HE Proposition	RHS Position (see responses to Deadline 5 for further reasoning)	Highways England's response
1.0 Traffic and transport, including traffic modelling and assessment of alternatives

Appendix A. Design Standards – RHS Alternative: Wisley left out

Appendix B. Design Standards – RHS Alternative: Ockham Park Junction – South Facing Slips

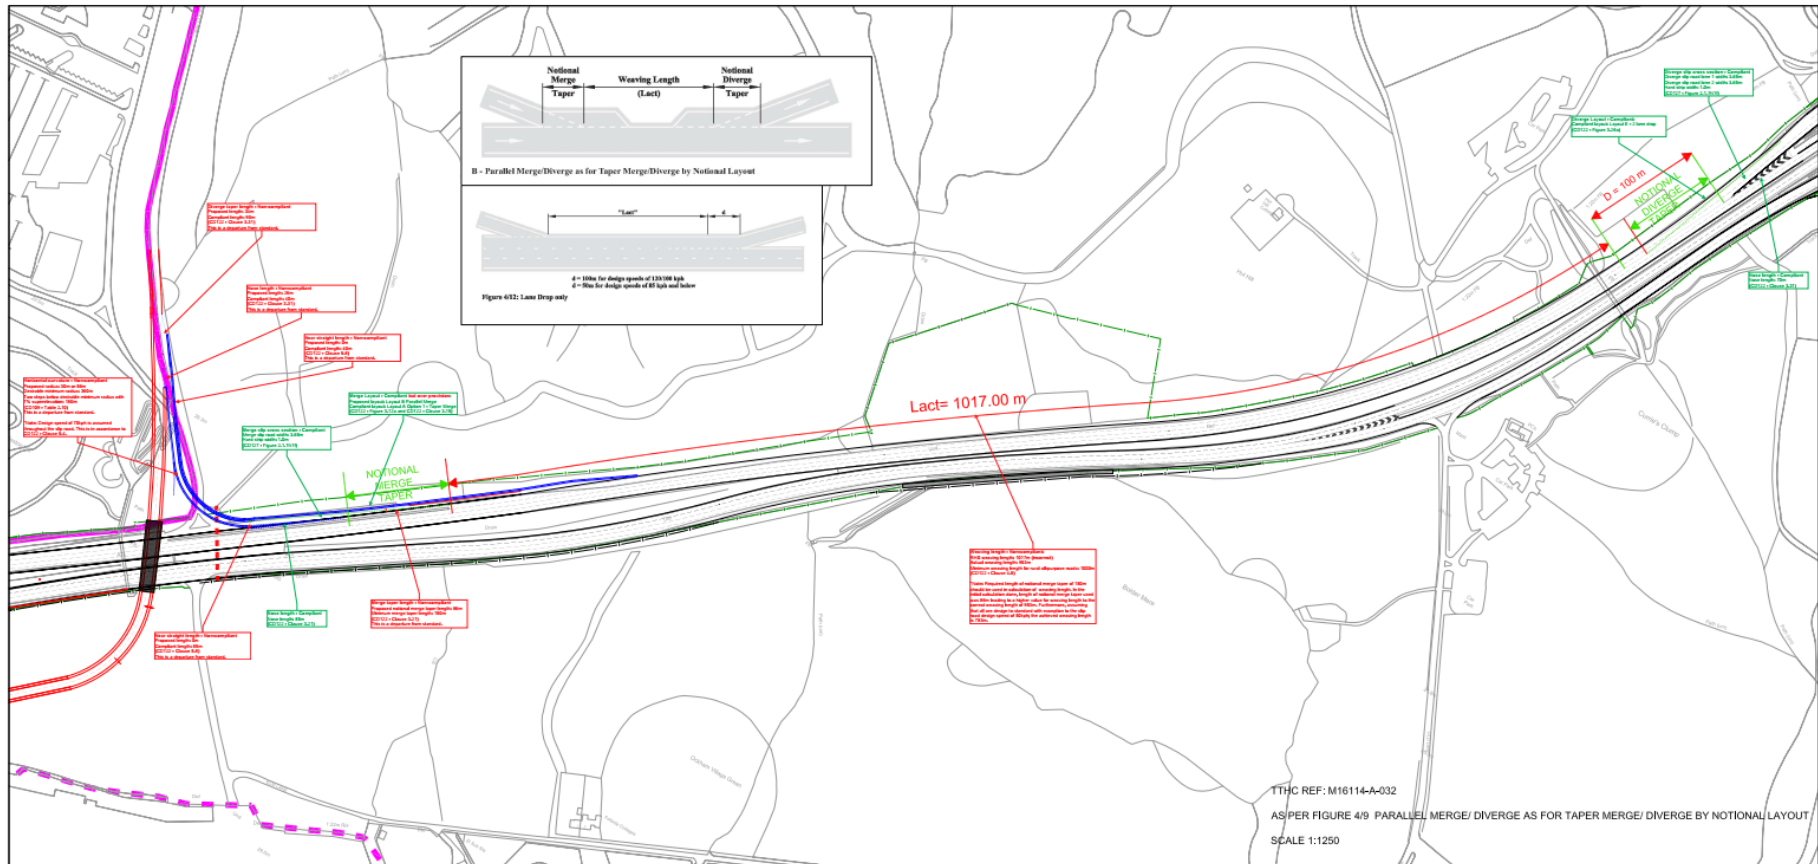
DMRB CD 122; *paragraph 5.4 and Table 5.4 Connector road design speed*, requires a slip road to have a minimum design speed of 70kph when the mainline design speed is 120kph, as is the case for northbound A3.

The RHS Alternative scheme does not comply with standards because the diverge taper length [34m] and nose length [26m] are less than that required by DMRB CD 122; *Table 3.31 Diverge layouts geometric parameters*.

The RHS Alternative scheme does not comply with standards because it makes no allowance for a Near Straight between the diverge back of nose and the radii between Wisley Lane and northbound A3.

DMRB CD 122 *paragraph 5.8* requires a near straight at least equal in length to the nose [40m] to be provided at the back of the nose.

The RHS Alternative scheme does not comply with standards because the radius linking the diverge on Wisley Lane with the northbound A3 merge is proposed to be either 56m or 30m when the desirable minimum radius is 360m.

As noted above the DMRB CD 122 *Table 5.4 Connector road design speed*. Requires the slip road to have a design speed of 70kph. As noted under Table 5.4, CD 109 (formerly TD 9/93) shall be used to determine the horizontal curvature.

DMRB CD 109 *Table 2.10 Design speed related parameters*. Requires for the 70kph Design Speed a minimum radius of 180m with 7% superelevation, which is two steps below the desirable minimum radius (360m),

The absolute minimum radius that can be provided is 90m with 7% superelevation but this would require the design speed to be reduced to 50kph, but this does not comply standards and therefore vehicles will have to negotiate the bend at low speed which will make it difficult for vehicles to merge on to the mainline that will be running at a higher speed.

The RHS Alternative scheme does not comply with standards because it makes no allowance for a Near Straight. DMRB CD 122 *paragraph 5.8* requires a near straight at least equal in length to the nose [85m] to be provided at the back of nose.

The RHS Alternative scheme is proposing a Layout B parallel merge (with auxiliary lane), however when using the traffic flows of 476 VPH for vehicles travelling on Wisley Lane south of RHS Wisley and 5493 VPH for vehicles travelling between Ockham and Wisley on the northbound A3, as presented in Appendix A of the Transport Assessment Supplementary Information Report (REP2-011) and inputting these in to DMRB CD122; *Figure 3.12a All-purpose road merging diagram*, the merge type should be a Layout A option 1 – taper merge.

Furthermore, there is no reason to provide a Layout B parallel merge because the three requirements in DMRB CD 122; *paragraph 3.15* do not apply.

The RHS Alternative scheme is proposing a Layout B parallel merge based on their interpretation of the Auxiliary Lane definition provided on page 7 of DMRB CD 122 “*An additional lane parallel to the mainline carriageway to provide increased merge or diverge opportunity or additional space for weaving traffic*”.

Whilst we agree that the auxiliary lane will increase the opportunity for traffic to merge from Wisley Lane on to the A3 Northbound, it should be understood that this will have a negative impact on the northbound A3 because the weaving length will be reduced for vehicles diverging off to the M25 junction 10.

The RHS Alternative scheme suggests a weaving length of 1017m is achievable, however assuming the above elements are designed to standard with the exception of a nonstandard design speed of 50kph, which would allow the horizontal curvature of 90m, when checking the weaving length using the parameters in DMRB CD 122; *Figure 4.4a and Figure 4.4h* the weaving length achieved is 783m, which does not comply with the standards because the weaving length is less than the 1km required by DMRB CD122; *paragraph 4.5*.

If the minimum horizontal curvature [180m] permitted for a design speed of 70kph and complying with standards were to be provided, this would further reduce the weaving length below 783m.

A3 Southbound Ockham Park Junction to Ripley Services

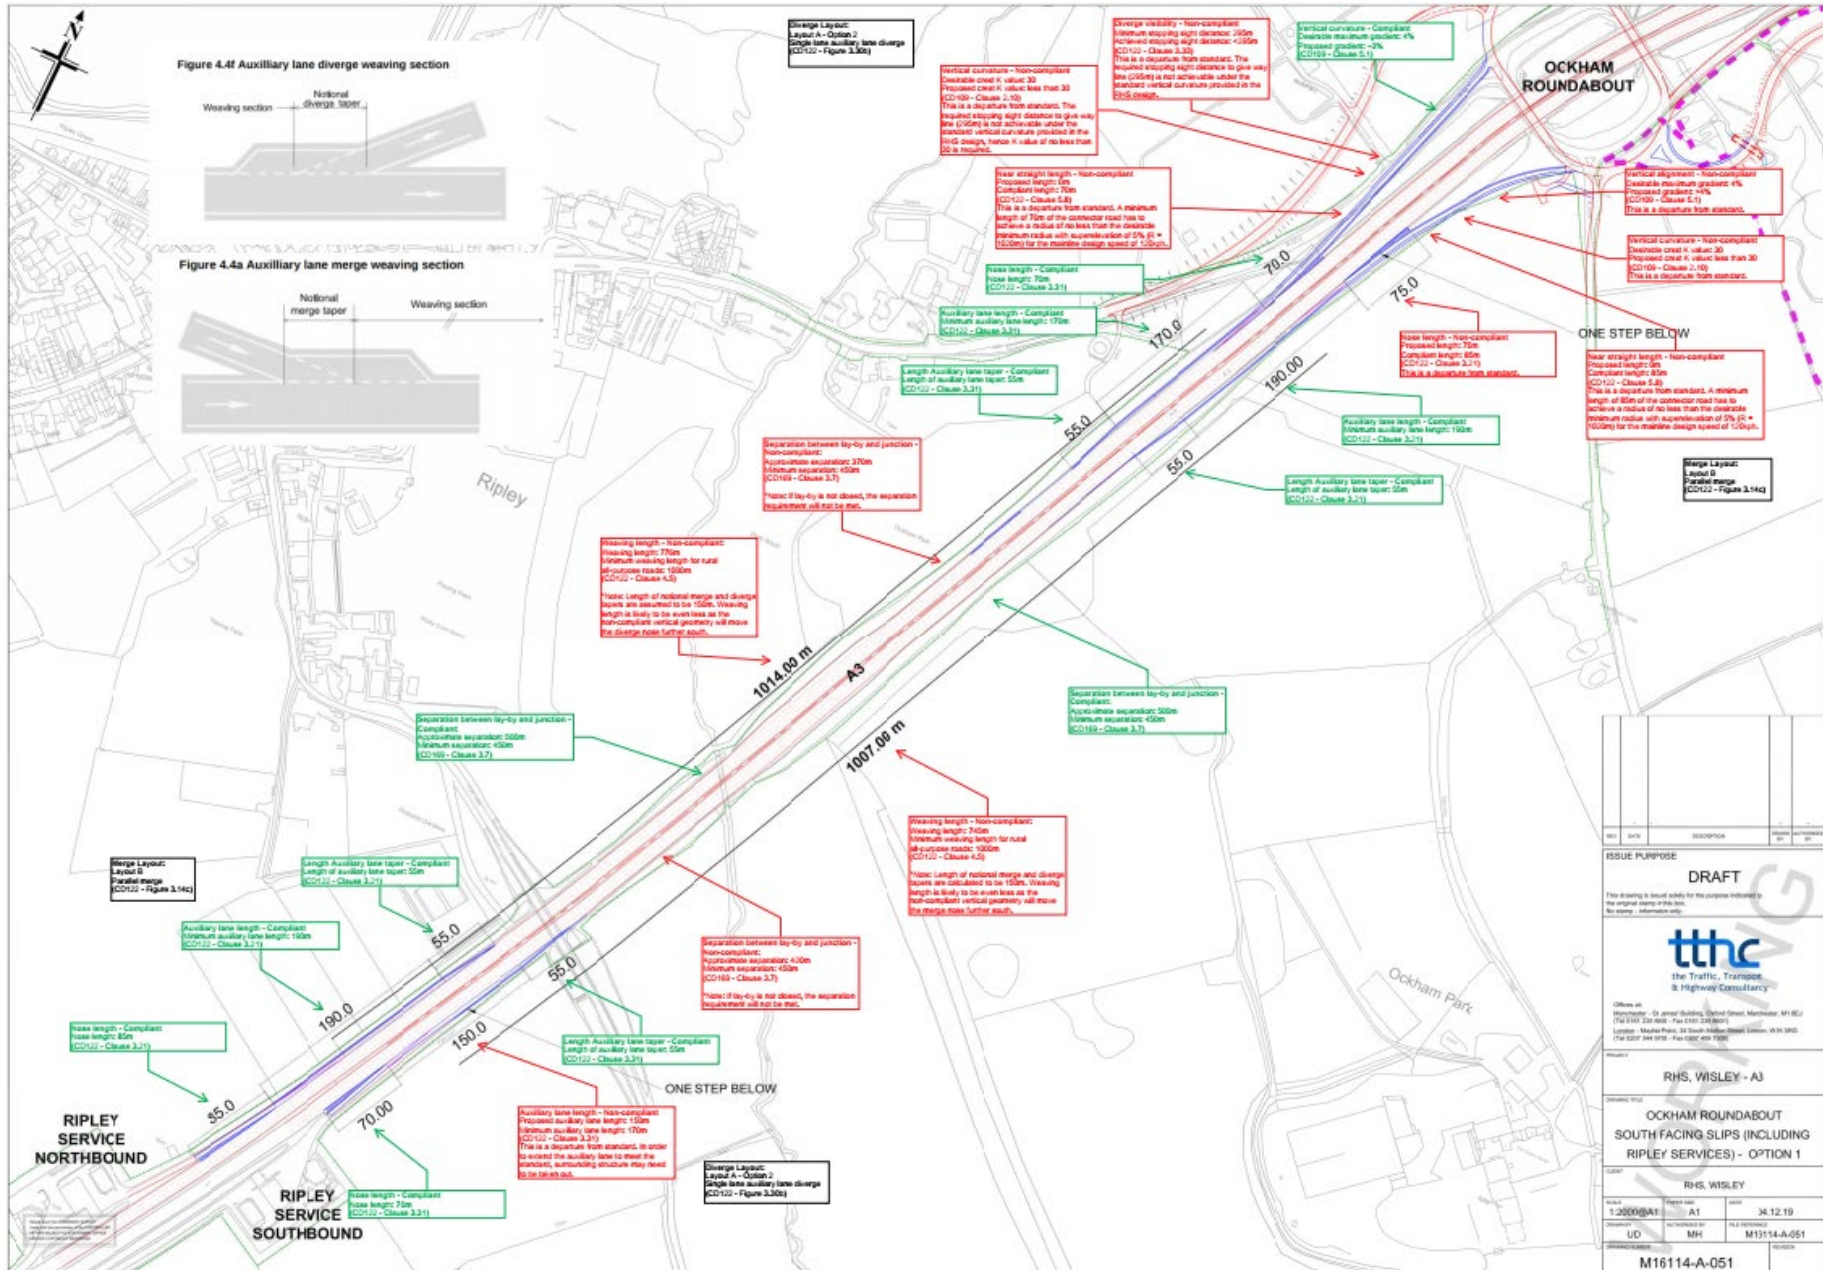
- a) The connector slip road linking the Ockham Park circulatory carriageway with A3 southbound mainline is not compliant with the requirements set out in the Design Manual for Roads and Bridges (DMRB); CD 122 - Geometric design of grade separated junctions. This is because:

- DMRB CD 122; paragraph 5.4 requires the slip road to be designed with a minimum design speed of 70kmph. The RHS Alternative design shows an insufficient length of slip road between the circulatory carriageway and the back of nose; it is not possible to fit the vertical geometry required by the design standards within this length.

- DMRB CD 122; paragraph 5.8 requires a length of near straight (with a radius no less than 1020m) to be provided at the back of nose, at least equal in length to the nose. The RHS Alternative design makes no allowance for a near straight.

- DMRB CD 122; paragraph 3.21 requires the nose length to be 85m. The RHS Alternative design provides a non-compliant 75m nose.
- b) The connector slip road linking the A3 southbound mainline with Ripley services is also not compliant with the requirements set out in DMRB CD 122 and CD169 - The design of lay-bys, maintenance hardstandings, rest areas, service areas and observation platforms. This is because:

- DMRB CD 169; paragraph 3.7 requires a separation of 450m between a lay-by and an at grade junction. The RHS Alternative design provides a separation of 420m between the existing lay-by and Ripley Services diverge.

- DMRB CD 122; paragraph 3.31 requires a minimum auxiliary lane length of 170m. The RHS Alternative design provides a non-compliant 150m for the auxiliary lane. If the minimum length were to be provided, it would require modification to the structure carrying Rose Lane over the A3.

- DMRB CD 122; paragraph 4.5 requires a minimum weaving length of 1000m between a full grade separated junction and a service area. The RHS Alternative design shows a weaving length of just over 1km, but as detailed above, other aspects of the design are not compliant. In addition, the RHS Alternative design has shown the notional merge and diverge to be less than the required 150m. To make the RHS Alternative design compliant, the weaving length would need to be significantly less than 1km
